MINUTES OF THE PRE-BID CONFERENCE
on the technical and procedural issues of preparation and submission of offers
under RFQ UNDP/Projects/197/2017

TENDER: RFQ UNDP/Projects/197/2017 “Supply and delivery of boiler plant (boiler unit and auxiliary equipment) and performance of associated services (installation supervision, start-up and adjustment works, commissioning and training)”.

DATE: 23 March, 2017 (11.00-14.30 Minsk time).

7) Schematic diagram of equipment:

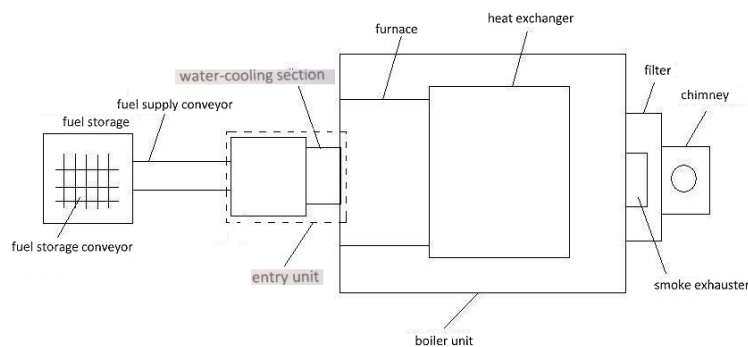
-Below provisions of Section “General Description of the Boiler Plant” of Annex 6 are hereby amended to read as follows:

4) Item 2.1.5, Subsection 2.1, Section 2:

“Fuel loading into the furnace:

a) Mechanized, with size of particles from 0.1 to 100 mm, provided the mass fraction of particles with size 0.1 to 3 mm is not more than 30%”

b) Water-cooling section is the gate between the fuel supply and the furnace. The section compensates the heat loss due to drying of the fuel”.
